Addendum No.: 4

Date of Addendum: May 4, 2020

Prudence Crandall Museum Renovations  
1 South Canterbury Road  
Canterbury, CT  
BI – RR – 28

2 SECTION AT RIDGE  
1" = 1'-0"

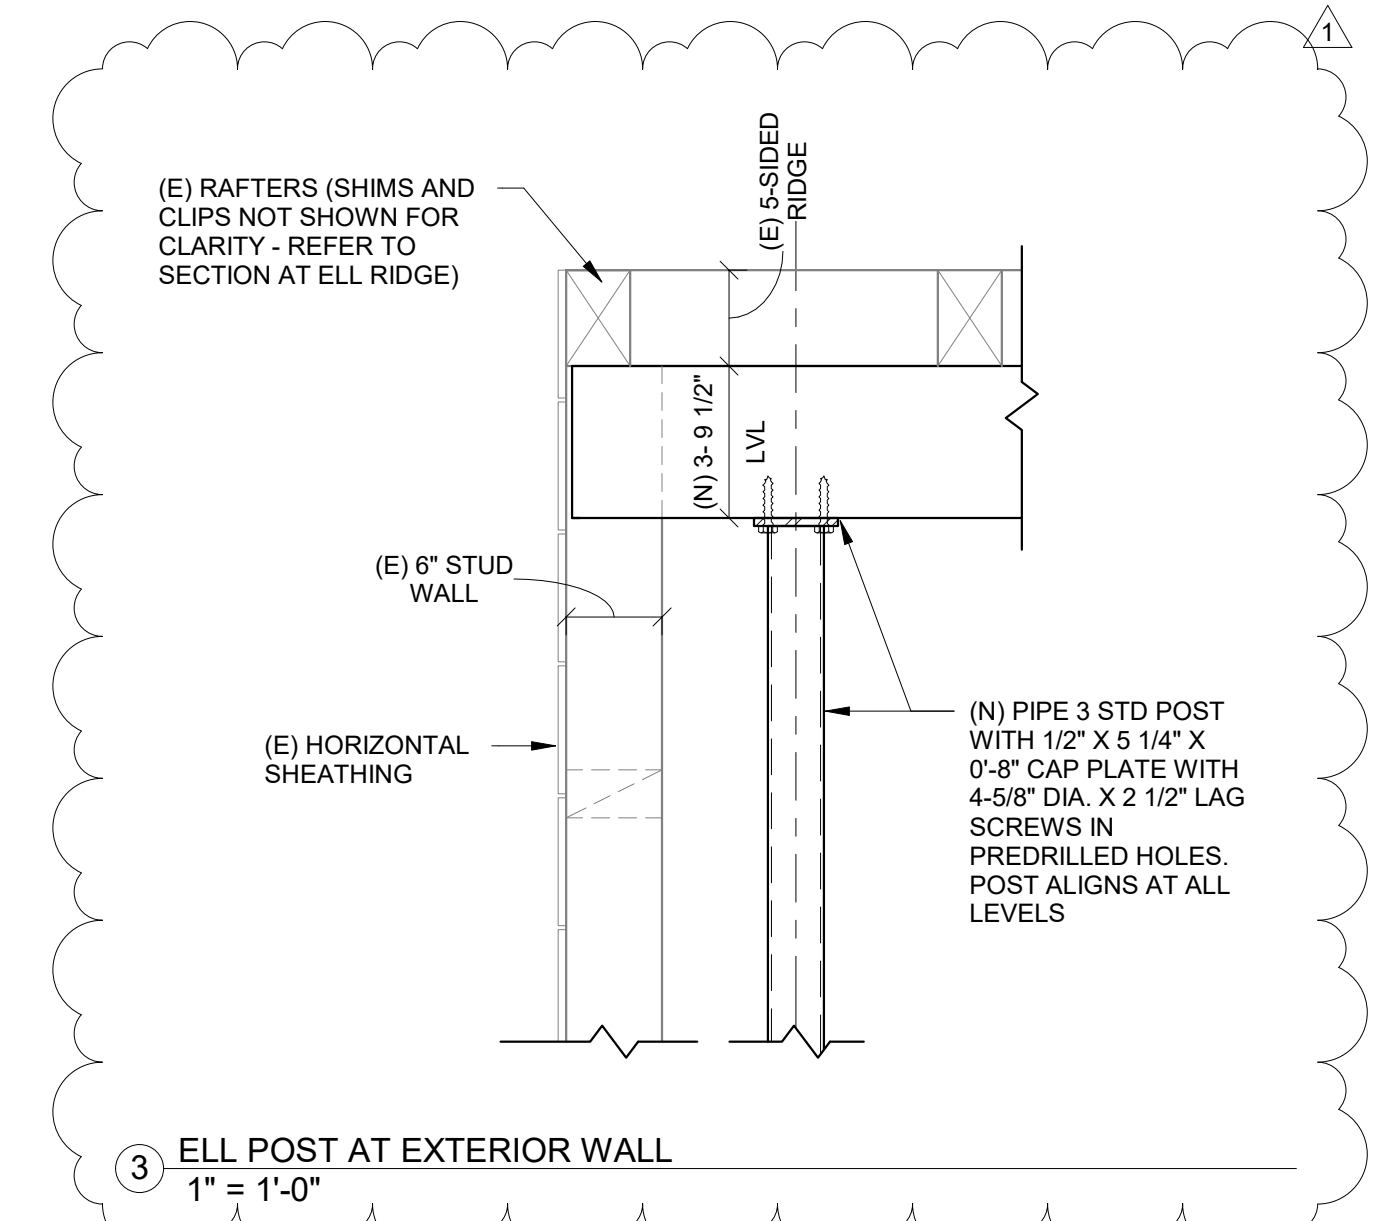
**Question 3:** *Drawing S-102 calls for a 3" pipe down at gridline E1. Drawing S-101 does not show a 3" pipe at E1. Drawing S-103 shows a representation of a pipe at E-1 with no call out. Please clarify if this pipe goes up or down, or both, or none?*

**RESPONSE:** Column should extend from ridge down to foundation. See revised structural drawings S-100, S-101, S-102, S-103, S-104, dated April 30, 2020, attached.

TYPICAL STITCH BOLT DETAILS

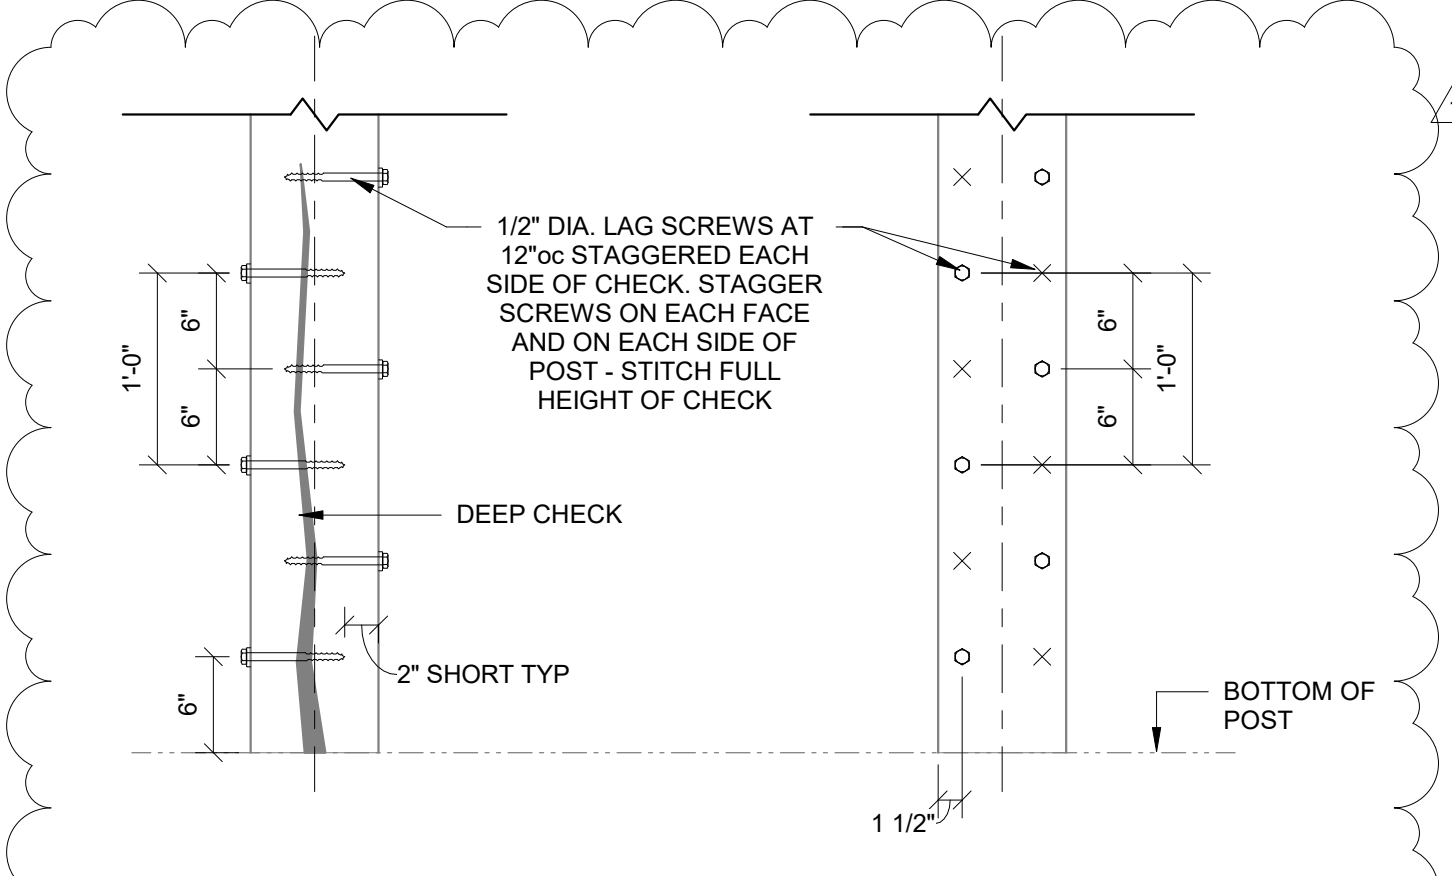
**Question 4:** *Dwg S300 calls for stitch bolting checked beams. Is it the intent to counterbore the wood beam as shown on the typical detail or should the hex head be exposed with a flat washer used?*

**RESPONSE:** Hex head to be exposed, with flat washer. See revised detail on structural drawing S-300, dated April 30, 2020.

**1** LCC COPPER RAIN DIVERTERS - 16 OZ  
1 1/2" = 1'-0"

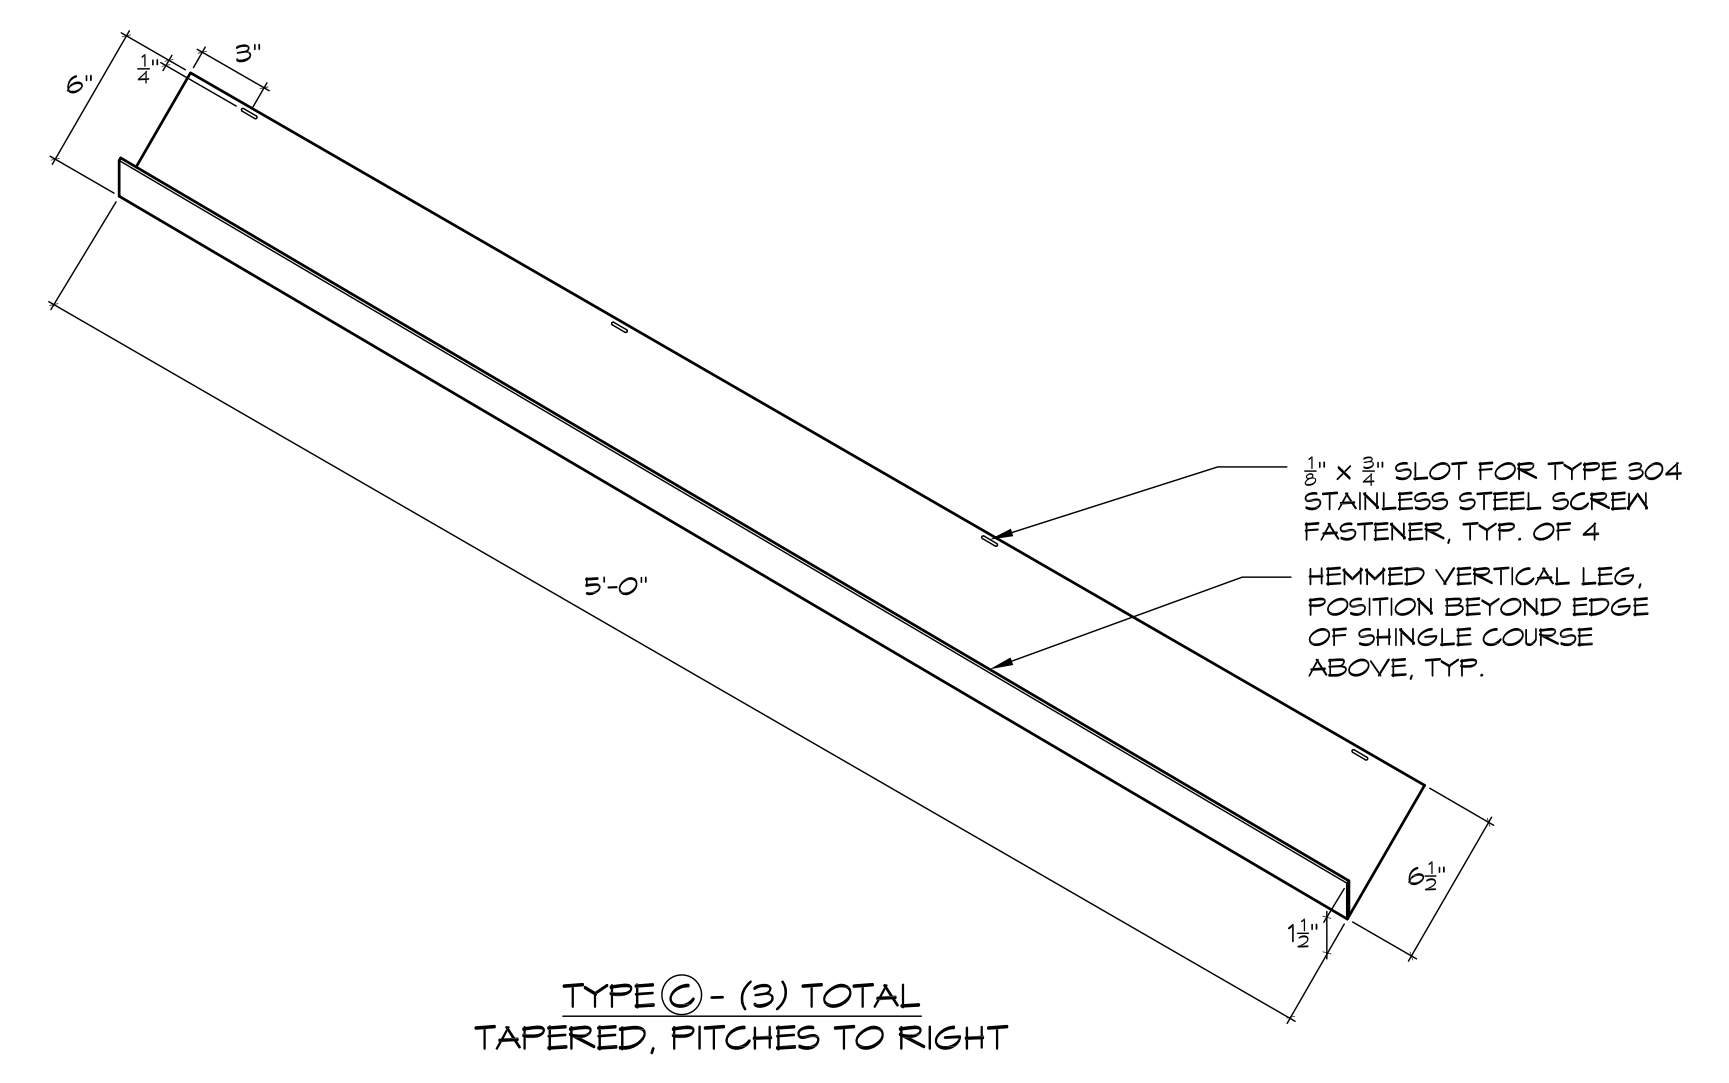
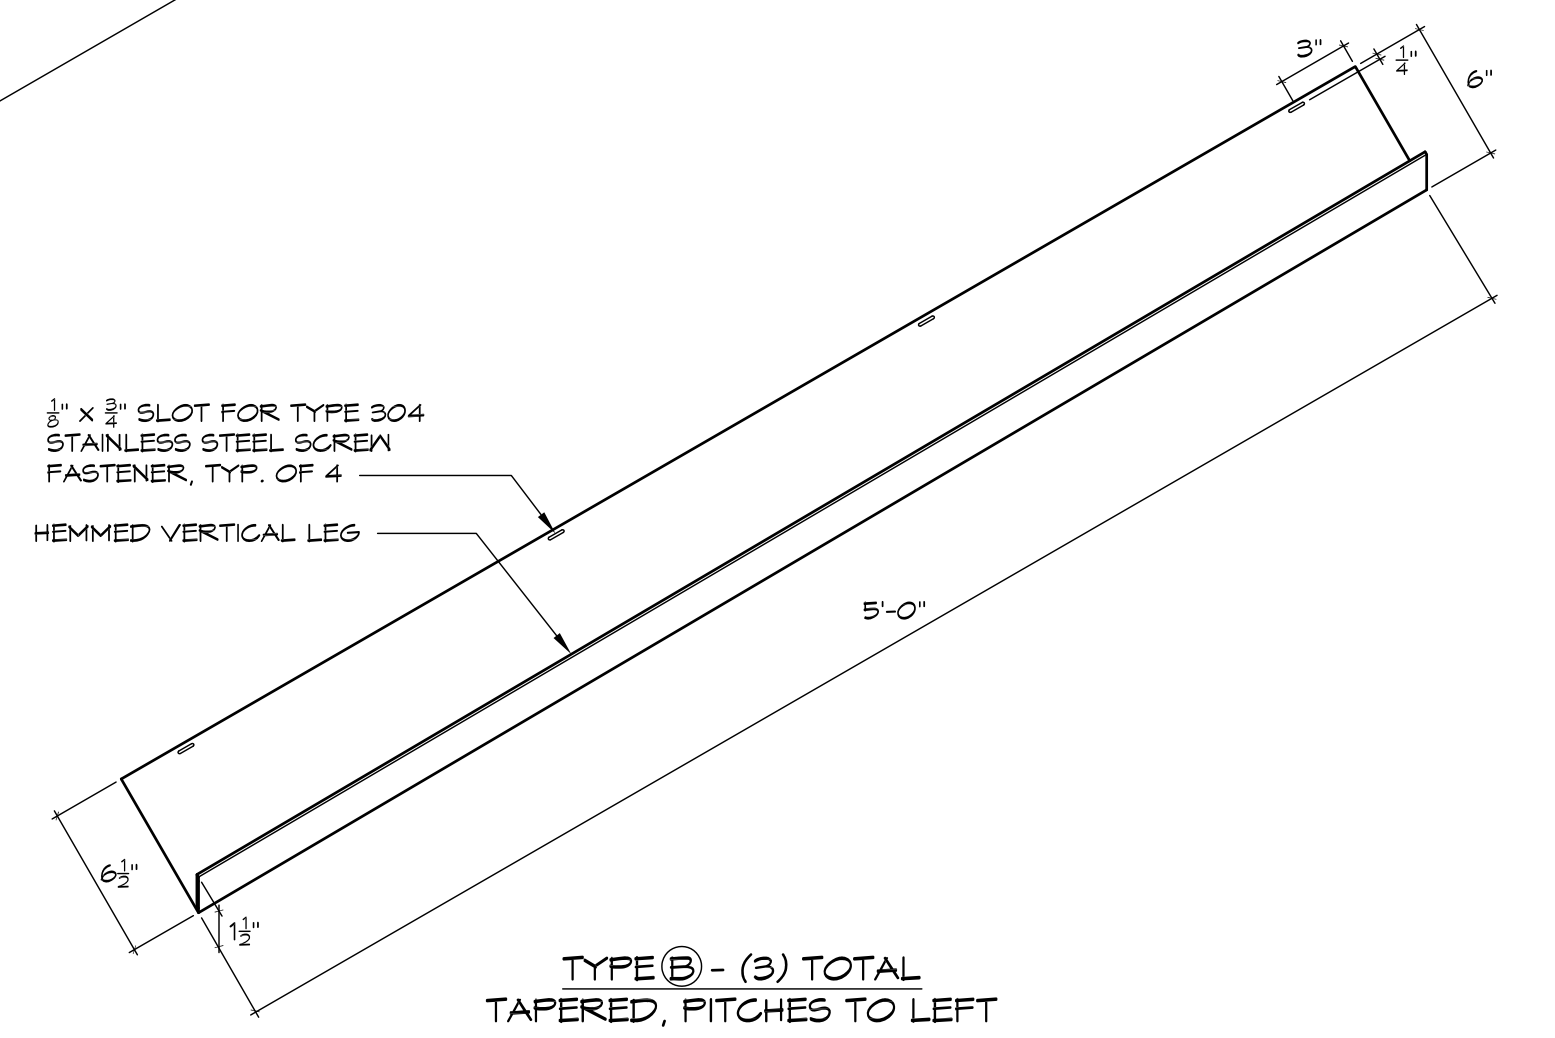
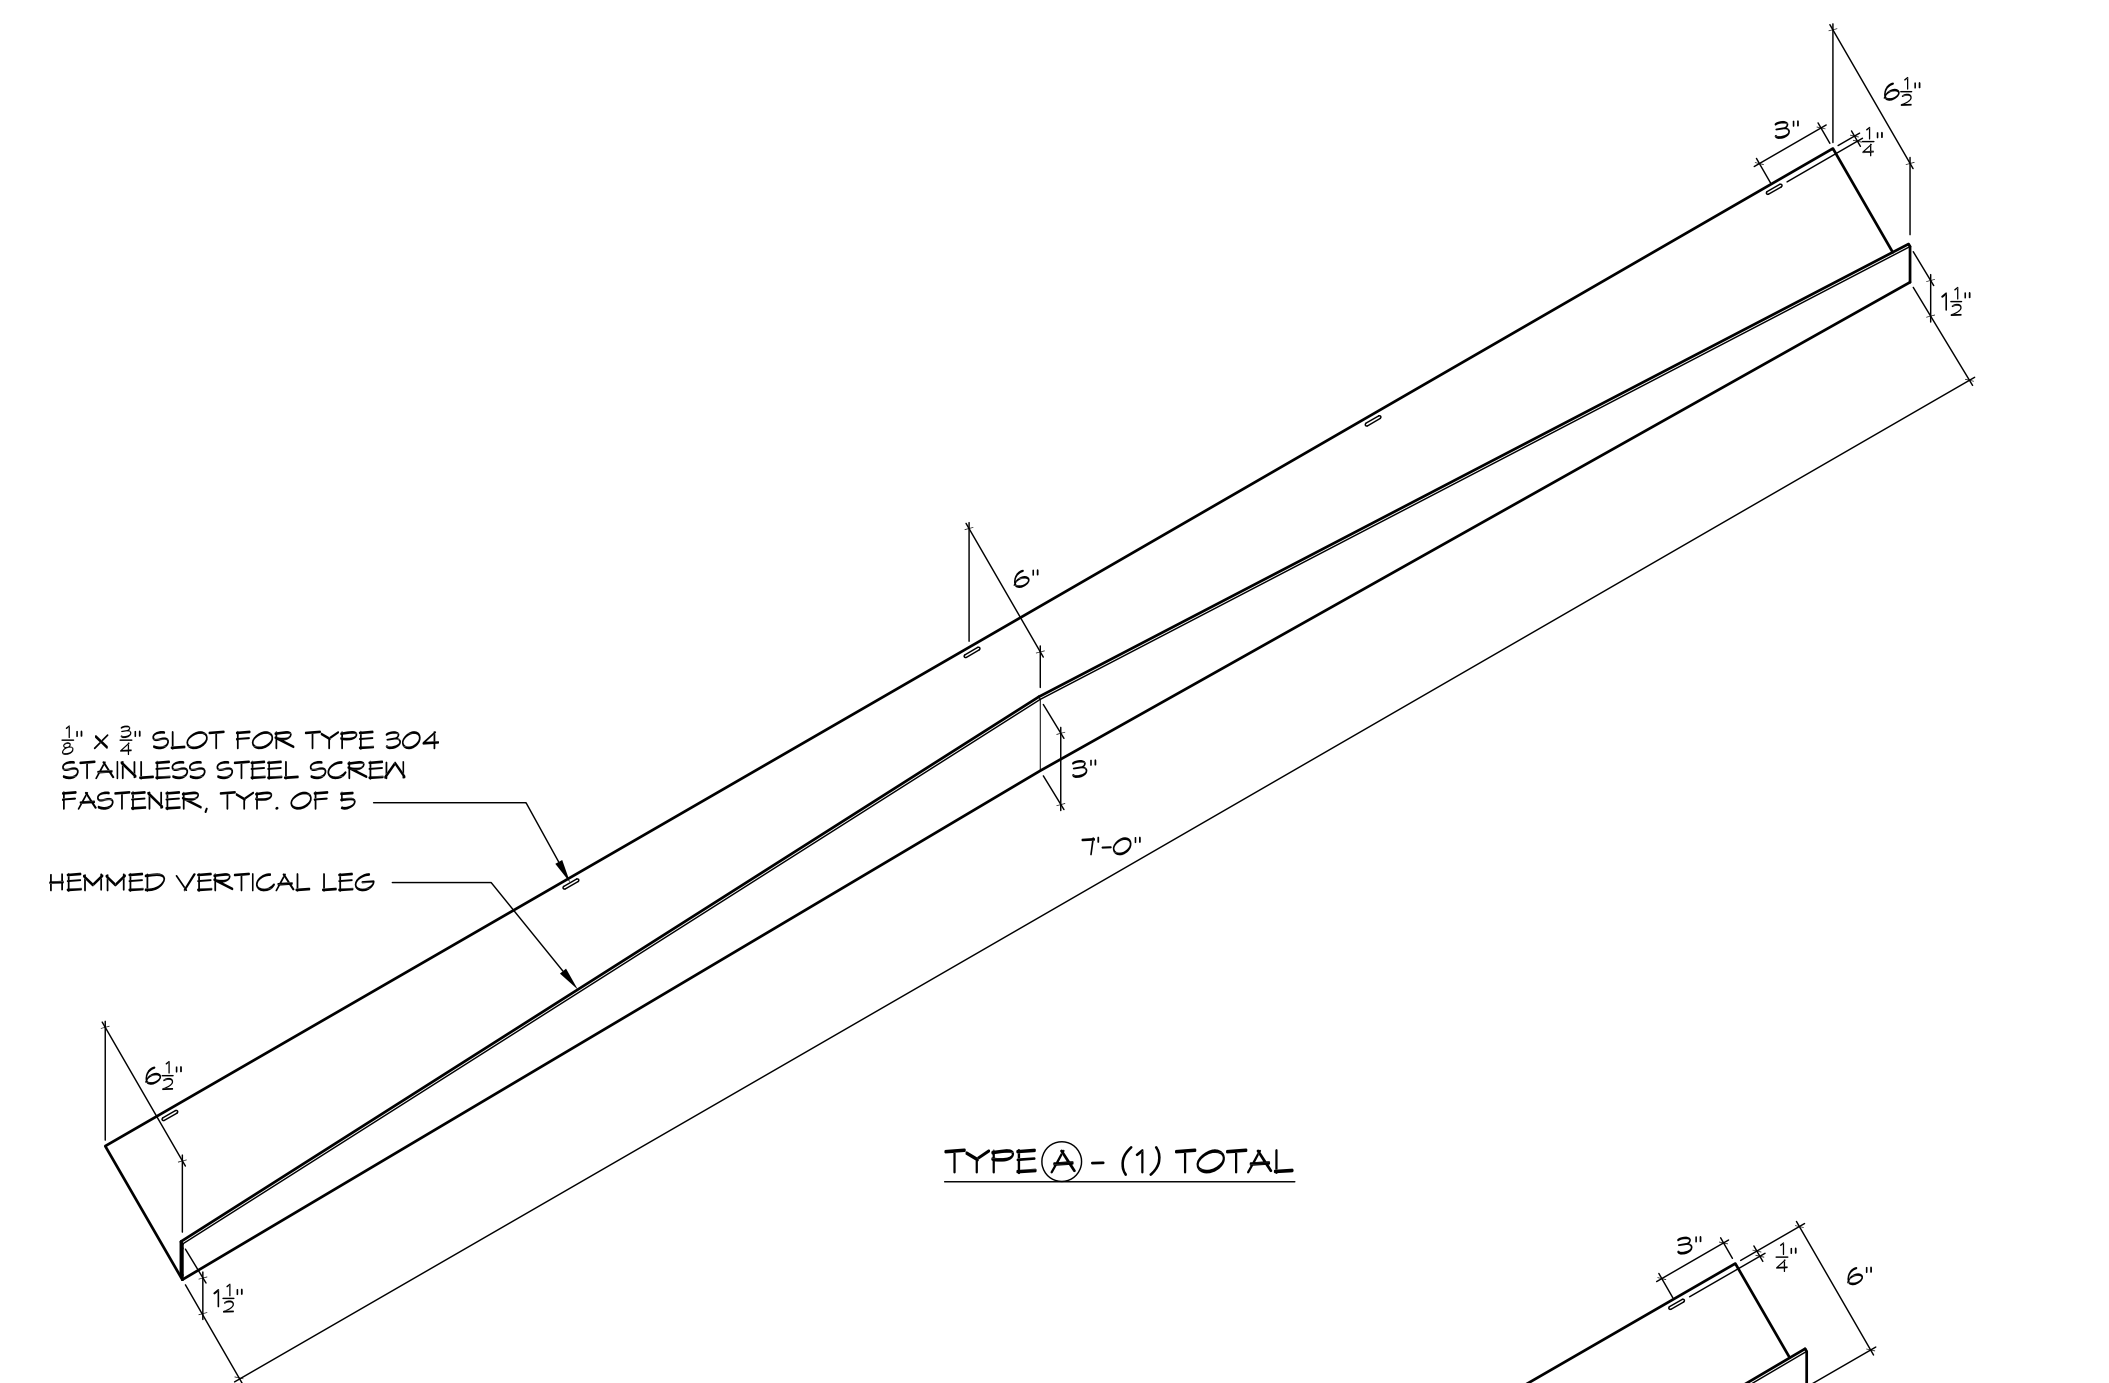
**Question 1:** *What is material thickness required for the LCC rain diverters?*

**RESPONSE:** Material thickness for LCC rain diverters to be a minimum of 16 oz. (24 gauge). See revised Architectural drawings A-104 and A-105, attached.
